SPARE PARTS LIST

560 XP/XPG

Illustrated part list IPL update

H560XP/XPG

1. Air filter

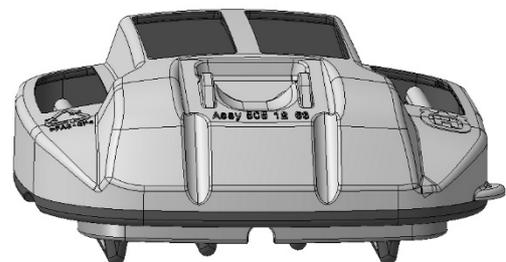
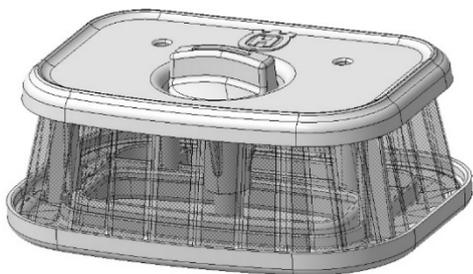
1. New improved design of air filter holder and air filter have been introduced.
2. We have introduced a new Cylinder cover assy 587 24 87-02 to fit the new filter solution. The new Cylinder cover is higher than the old one.
3. Four new Filter unit kits have been added, if users want to update old chain saws to the new Filter system.
598 93 45-01: New filter 25 µm 590 45 88-02 + New Filter holder 597 27 55-01. **XP**
598 93 45-02: New filter 25 µm 590 45 88-02 + New Filter holder 597 27 55-02. **XPG**
598 93 47-02: New filter 25 µm 590 45 88-02 + New Filter holder 597 27 55-01 + New Cylinder Cover 587 24 87- 02. **XP**
598 93 47-03: New filter 25 µm 590 45 88-02 + New Filter holder 597 27 55-02 + New Cylinder Cover 587 24 87- 02. **XPG**

1. Filter holder assy 597 27 55 and air filter assy 590 45 88 are NOT exchangeable.
2. Cylinder cover assy is fully exchangeable. New cover fits on old saws.

590 45 88-01/-02/-03

505 12 63-04/-05/-06/-07
